**Appeal of Board of Zoning Appeals Decisions Related to**

# **United Village**

## **Restaurant Pavilions**

**Zoning File: #24-033509 (Appeal of Zoning file #24-023545)**  
**1566 University Ave W (Temporary Address)**

4 NORTH ELEVATION - F11  
3/16" = 1'

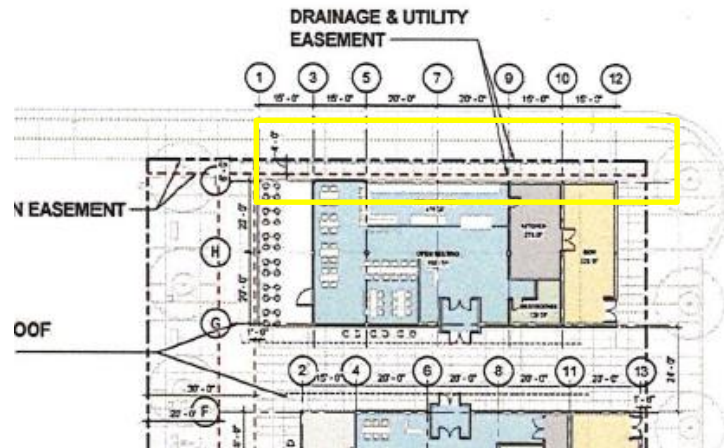
- Northern Façade: 19.6%, 10.4% variance

Dark blue box is about 153 square feet. (Size of shortage.)

3. There are opportunities to increase the window percentage to meet the requirement on the northern façade, given that the uses along the northern façade are primarily the dining room and serving area. **This finding is not met for the 19.6% request for the northern façade.**

4. The request for a variance of the window and door percentage on the northern façade seems to be self-created, as the zoning code does not prohibit windows in serving areas. **This finding is not met for the 19.6% request for the northern façade.**

**BZA denied the northern façade variance request (19.6% proposed) based upon finding 3 & 4.**

F1 A - North Elevation

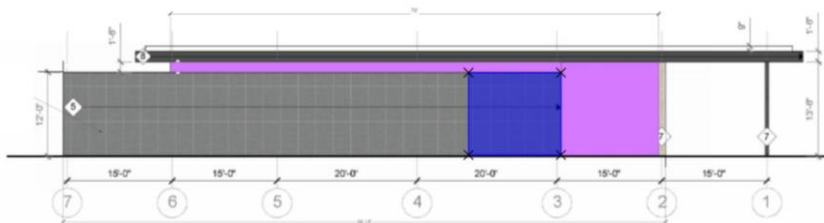
1. 19.6%
2. 19.6%
3. 71%
